Supporting Materials for comments #181, 188, 190, 194, 195, 196, 197, 201, 202

Jeff Slavick

10 July, 2017

Table 136-12—Coefficient initial conditions

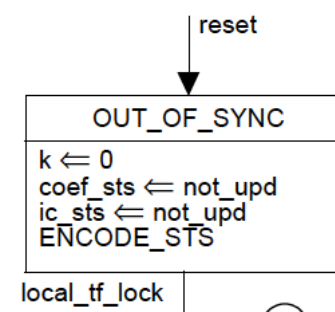
136.9.3.1.3 states that when Figure 136-9 enters the OUT_OF_SYNC state the TxEq should be set according to Table 136-12 (Preset1 = NoEq). However, in Figure 136-9 there is no "load" of that Equalization value.

- In Figure 136-9 the OUT_OF_SYNC state just updates the status field, but does not change the local EQ. But 136.9.3.1.3 states the EQ should be set to a particular value.

- Add UPDATE_IC to OUT_OF_SYNC (before ENCODE_STS) into Figure 136-9
- Change 136.8.11.4 to be
 - When a change in the initial condition request bits is detected or a reset occurs, the coefficients are configured in a manner consistent with the following algorithm.

```
if reset or mr_restart_training
  Set coefficients to OUT_OF_SYNC
  ic_sts = not_upd
else
  if ic_req = ind_ctl
    ic_sts = not_upd
  else
    if ic_req = preset 1
      set coefficients to preset 1
    else if ic_req = preset 2
      set coefficients to preset 2
    else if ic_req = preset 3
      set coefficients to preset 3
    end if
  end if
end if
```

Figure 136-7—PMD control state diagram

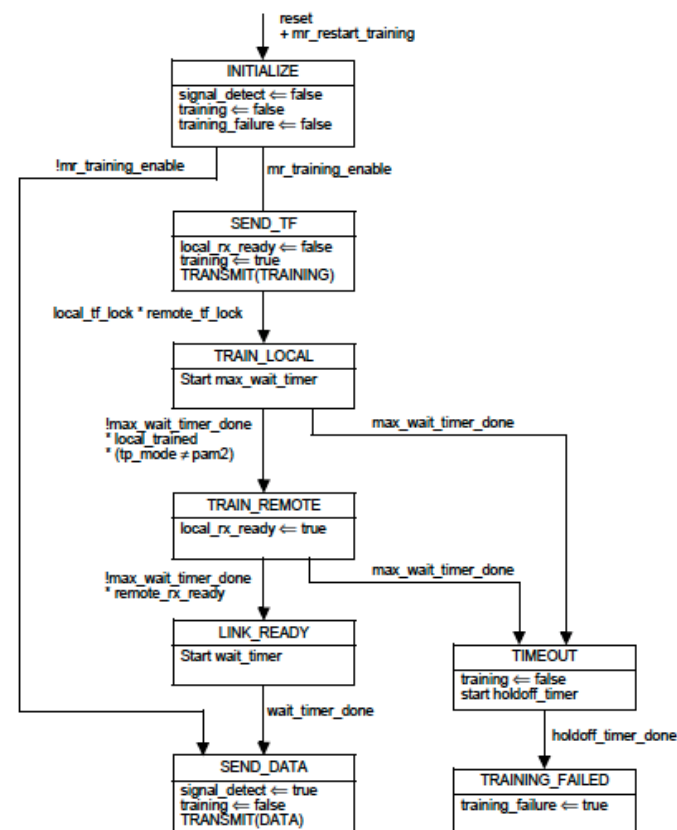
The Receiver Frame Lock bit is forced to 0, only during a training startup condition. It should also be forced low when in the TIMEOUT and TRAINING_FAILED states. local_tf_lock is forced low, but that does not force an ENCODE_STS to occur (the function that currently encodes transmitted status bit for receiver frame lock based on local_tf_lock)

- ENCODE_STS is mapping the local_tf_lock variable to Status frame being transmitted. There's some extra requirements placed on the transmitted Status frame in 136.8.11.3.3 to try and ensure it's low when you start-up training and if you enter TIMEOUT or TRAINING_FAILURE (via forcing local_tf_lock low by setting training false).
- However, there is no call to ENCODE_STS in Figure 136-7 to cause the transmitted Status frame to be updated when training becomes false.

- In 136.8.11.7.2 update ENCODE_STS function as follows
 - ENCODE_STS
 - Encodes portions of the status field of transmitted training frames.
~~local_tf_lock is mapped to the receiver frame lock bit~~, k is mapped to the coefficient select echo bits, coef_sts is mapped to the coefficient status bits, ic_sts is mapped to the initial condition status bit, local_rx_ready is mapped to the receiver ready bit, and tp_mode is mapped to modulation and precoding bits (see 136.8.11.3.2).
- Change 2nd sentence in the definition of
136.8.11.3.3 Receiver frame lock

Receiver frame lock shall be set to 0 upon entering TRAINING mode and shall not be set to 1 until local_tf_lock is true.
- To: Receiver frame lock shall be set to 0 when the variable training is false and it shall not be set to 1 until training and local_tf_lock are both true.

- Transmitted receiver frame lock status indicator is based solely on description in 136.8.11.3.3 which will force the bit in the status frame bit to be 0 when Figure 136-7 is in the INITIALIZE, TIMEOUT or TRAINING_FAILURE states, low until local_tf_lock becomes true in the SEND_TF state and is otherwise managed by the local device in TRAIN_LOCAL, TRAIN_REMOTE and SEND_RDY states based upon it's ability to comply with 2ms response time.
- By not forcing local_tf_lock low when in TIMEOUT or TRAINING_FAILURE it allows for frame lock to be maintained locally when one side has timed out, but other is still running training (has yet to timeout). Which provides some debug capability and aligns with how Clause 72 acts.

Figure 136-7—PMD control state diagram

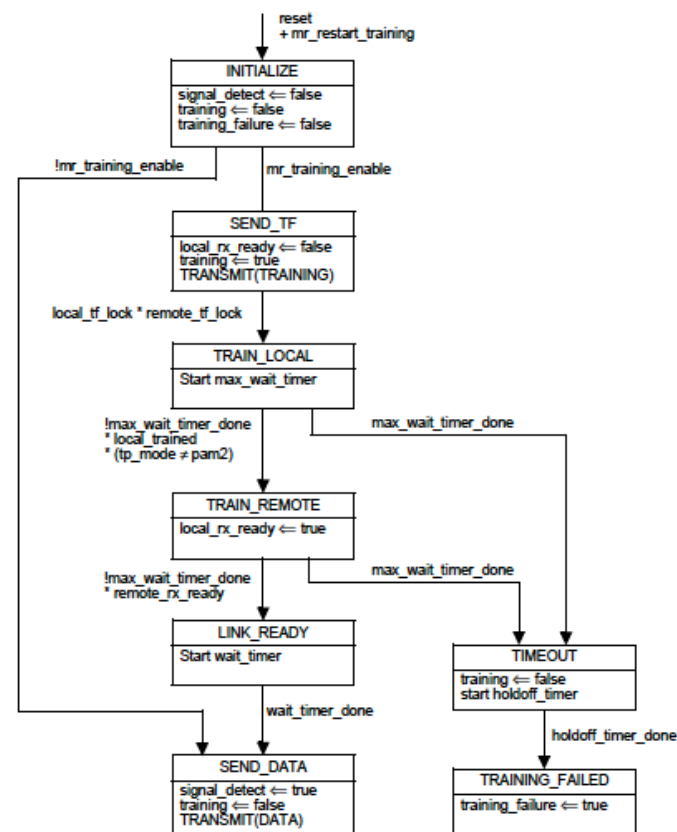
ENCODE_STS maps local_rx_ready into the transmitted status frame. But it's only called when the remote partner modifies his transmitted frame. So when the local side transitions to TRAIN_REMOTE state, until the partner sends a change in his Control Frame they won't see that you're done. The local side should push it's local_rx_ready status to the partner based on it's state.

- Local_rx_ready is updated in training FSM. But ENCODE_STS is not called by that FSM. So there's no locally initiated process to update the transmitted Status field when local_rx_ready asserts.

- In 136.8.11.7.2 update ENCODE_STS function as follows
 - ENCODE_STS
 - Encodes portions of the status field of transmitted training frames. local_tf_lock is mapped to the receiver frame lock bit, k is mapped to the coefficient select echo bits, coef_sts is mapped to the coefficient status bits, ic_sts is mapped to the initial condition status bit, ~~local_rx_ready is mapped to the receiver ready bit,~~ and tp_mode is mapped to modulation and precoding bits (see 136.8.11.3.2).
- Change 136.9.8.11.3.1 to read
 - The receiver ready bit is used to signal the local receiver state to the link partner. When this bit is 1, it indicates that the local receiver has completed training and is prepared to receive data (**local_rx_ready is true**). When this bit is 0, it indicates that the local receiver is requesting that training continue (**local_rx_ready is false**).

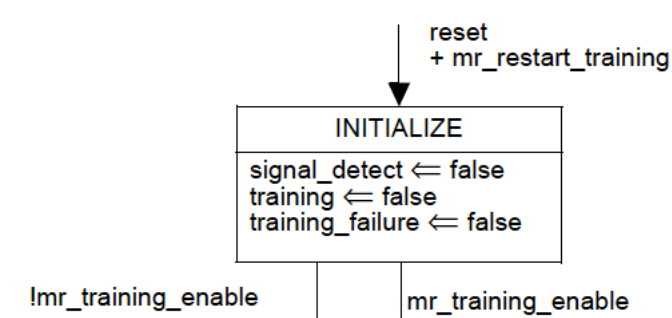
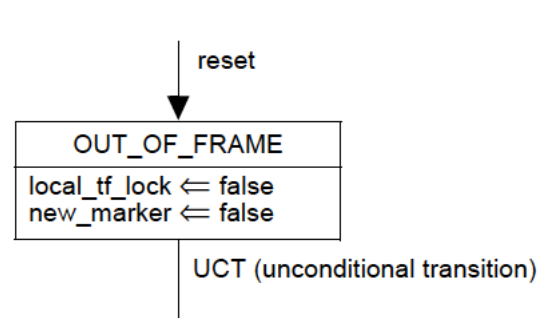
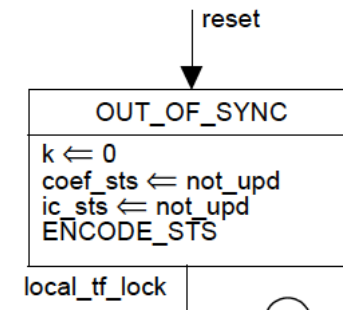
The training FSM maybe run through a reset sequence without the PMD being reset. When that happens, the Frame_lock and Coeff_Update FSM blocks should also be placed into their Reset states.

- In Figures 136-7,8,9 the condition to enter the “RESET” state is not consistent. When you reset the training process only “mr_restart_training = true” all FSM related to training should be placed into a reset state.

- To align all 3 FSM reset states
 - Add “+ mr_restart_training” to the entry condition to OUT_OF_FRAME in Figure 136-8
 - Add “+ mr_restart_training” to the entry condition to OUT_OF_SYNC in Figure 136-9

Figure 136-9—Coefficient update state diagram

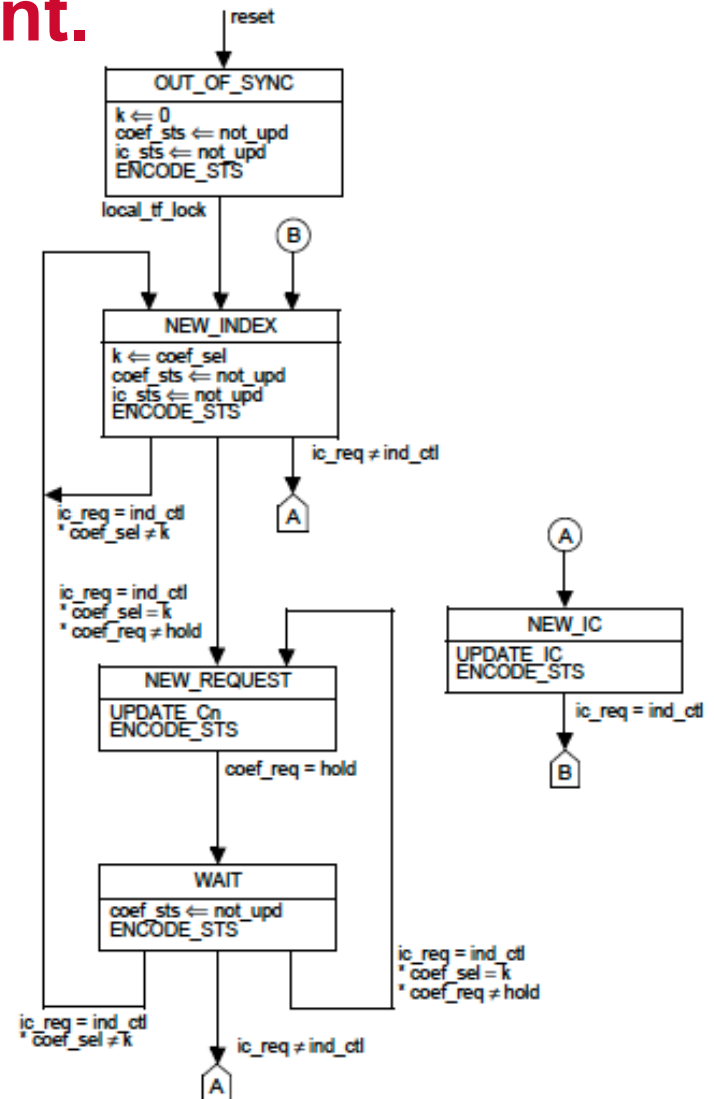
The algorithm in this section does not set `coef_sts = not_upd`, that is done in Figure 136-9. But when you change the `coef_req` from INC/DEC/NOEQ to HOLD that is a change in the coefficient request bits. So now you have the FSM (Figure 136-9) and this algorithm fighting each other. This algorithm would set `coef_sts = UPDATED` for HOLD (but not change the setting) while the FSM sets the response properly to NOT_UPDATED

- On coef_req change to HOLD, 136.8.11.5 algorithm stays coef_sts = UP while Figure 136-9 says coef_sts = NUP (WAIT state).
- On a coef_sel change, coef_sts would become UP per 136.8.11.5 while 136-9 says it's NUP (NEW_INDEX state). Changing the “selector” field should only modify the coefficient select echo field and not coef_sts field.

- The algorithm in 136.8.11.5 should only run when UPDATE_Cn is called in Figure 136-9. This occurs when coef_req is changed from HOLD -> INC/DEC/NOEQ. Changing coef_req back to HOLD and changes to coef_sel do not cause UPDATE_Cn to be executed.
- **Change 136.8.11.5 to read**
 - When a request to update a coefficient setting is detected in the coefficient request bits, the corresponding coefficient update is performed in a manner consistent with the following algorithm.
